LINCOLN CITY/LANCASTER COUNTY PLANNING STAFF REPORT

P.A.S.: Old Mill Village Preliminary Plat #03003

PROPOSAL: To preliminary plat 115 residential lots and one Outlot on approximately 28.76 acres.

To:	Tom Cajka, Planning Department
From:	Chad Blahak, Public Works and Utilities
Subject:	Old Mill Village Preliminary Plat #03003
Date:	8/07/03
cc:	Randy Hoskins Devin Biesecker

Old Mill Village SITE PLAN EXHIBIT

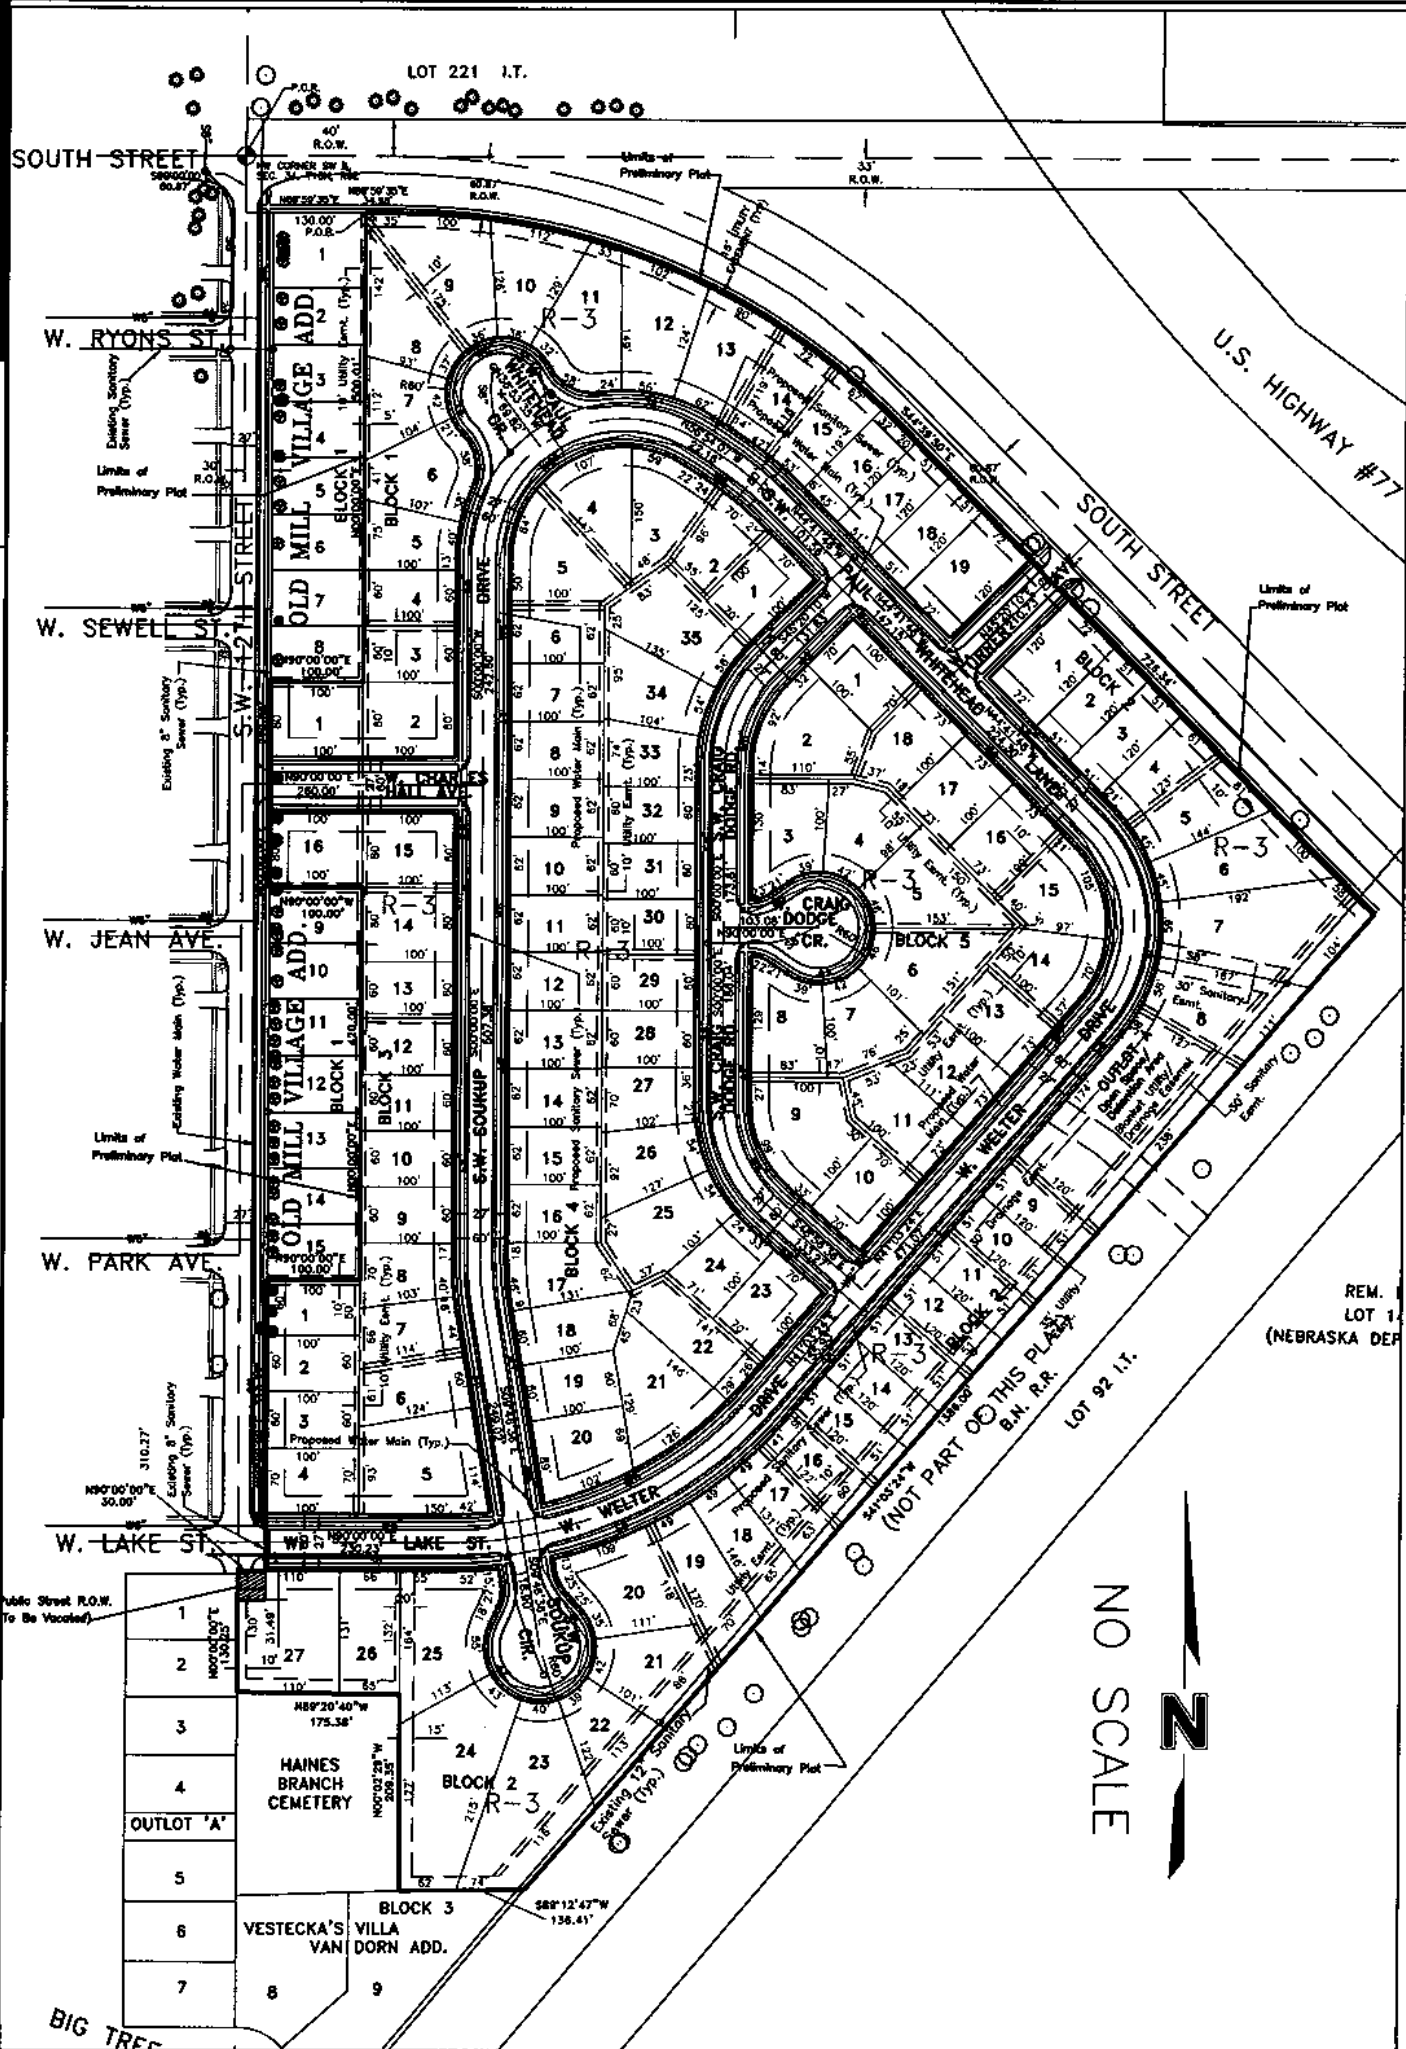
1. After the subdivider completes the following instructions and submits the documents and plans and 6 copies to the Planning Department office, the preliminary plat will be scheduled on the City Council's agenda: (NOTE: These documents and plans are required by ordinance or design standards.)
 - 1.1 Revise the preliminary plat to show:
 - 1.1.1 A correct legal description.
 - 1.1.2 Change Avenue to street in Note 23A.
 - 1.1.3 Add utility easements as requested by July 29, 2003 L.E.S. report.
 - 1.1.4 Show minimum opening elevations for Lots 8 and 9 Block 2. Both lots are adjacent to the detention pond.

- 1.1.5 Add to Note 23 the waiver for improvements of South St. to urban standards.
- 1.1.6 Add street trees on S.W. 12th St. for those lots abutting S.W. 12th St. Revise the landscape schedule accordingly.
- 1.1.7 Revise the grading and drainage plans to the satisfaction of Public Works & Utilities Department.
- 1.1.8 Make corrections as outlined in Public Works and Utilities report of August 1, 2003.

- The K-value for vertical curve at station 1+80 in the Charles Hall Avenue profile does not meet design standards and should be revised.
- The drainage study indicates that there is more runoff for the 10yr storm with the proposed development than for the existing conditions. As the runoff is ultimately discharged onto NDOR property, the NDOR should be consulted for permission to discharge the higher flow onto its property.

- The requested waiver for sanitary sewer running opposite street grades is acceptable as it does not produce sewer depths in excess of the 15' maximum.

- The requested waiver of design standards for constructing South Street with curb and gutter is acceptable to Public Works. However, the required sidewalk along South Street needs to be shown on the plans along with the grading necessary to construct the sidewalk at the standard elevation relative to the theoretical top of curb in South Street. If a deviation from the standard is required, the locations need to be indicated and justification needs to be provided.

- A culvert needs to be shown under Furrer Street at the South Street intersection. The grading necessary for the construction of the culvert, allowing for positive drainage to the railroad ditch, must also be shown.

- The proposed street names seem excessively long and consideration should be taken to shortening them.
- The proposed new culvert under the railroad tracks needs to be shown on the plans along

with grading necessary to construct the culvert. Drainage area and pipe sizing calculations must also be provided verifying the adequacy of the proposed culvert.

1. Need to have minimum opening elevations assigned to Lots 8 and 9 in Block 2. Both lots are adjacent to the detention pond.
2. Post development flows exceed pre developed flows for the 2 and 10 year storm events. The detention cell must be sized so that post development flows do not exceed pre developed flow rates.

Enclosed are 7 copies of the revised preliminary plat for the above referenced project. The drawings have been revised in response to the staff comment letter dated March 8, 2003.

1. The note referring to sanitary sewer in SW 12th Street has been revised.
2. The request for waiver of storm water detention is being recalled. Three copies of detention calculations are enclosed with this submittal.

3. The grading & drainage plan has been revised in response to Public Works comments. Note that the top of rail elevation of the adjacent railroad is approximately 2 feet below the grade at the property line. Establishing minimum building elevations is unnecessary.

4. The Burlington Northern Santa Fe Railroad has been contacted regarding construction of storm sewer on its property. A copy of an e-mail stating their position on the subject is attached. No storm sewer is proposed on NDOR property and proposed discharge rates are similar to existing conditions.

5. West Lake Street is shown aligned with the existing street.
6. The portion of SW 12th Street south of W. Lake Street is shown to be vacated.
7. Furrer Drive has been added connecting Paul Whitehead Drive to South Street.

8. Street grades have been revised. The request for waiver of design standards for the approach grade of W. Lake Street to Soukup Drive is maintained. The intersection of W. Lake and Soukup cannot be raised without creating drainage concerns on Soukup Drive and jeopardizing the borrow requirements of NDOR.

9. The requested changes to street names have been made. Leydon Circle has been renamed Paul Whitehead Circle.
10. Fire hydrant spacing has been revised per design standards.
